February 12, 2024

RE: Potential issue with CA-GREET 4.0 Electricity Emission Factor

3. <u>Default Regional EF-Electric tab:</u> This screenshot displays the electricity emissions factor used in the Tier 1 calculators. The example below is from the SRMW sub-region, which was scored at 826 gCO2e/kwh.

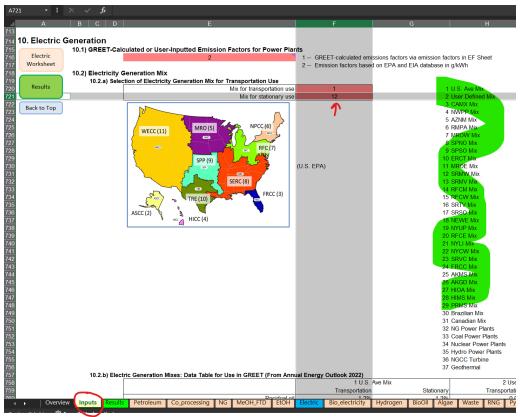
4. <u>Subregion Selection-Inputs tab:</u> Screenshot 2 is looking for something 11 and under, but since there are 27 subregion selections, the vast majority (subregion selections 12 - 27) will drive the formula above to IFERROR correct to the U.S. average. This does not seem correct. Even if this were to be the case, for any subregion selection 11 and under, the INDEX formula operates "correctly," but then pulls a reference for an NERC region which has no association with the eGRID subregion selection the user made, which in turn drives an inaccurate calculation.
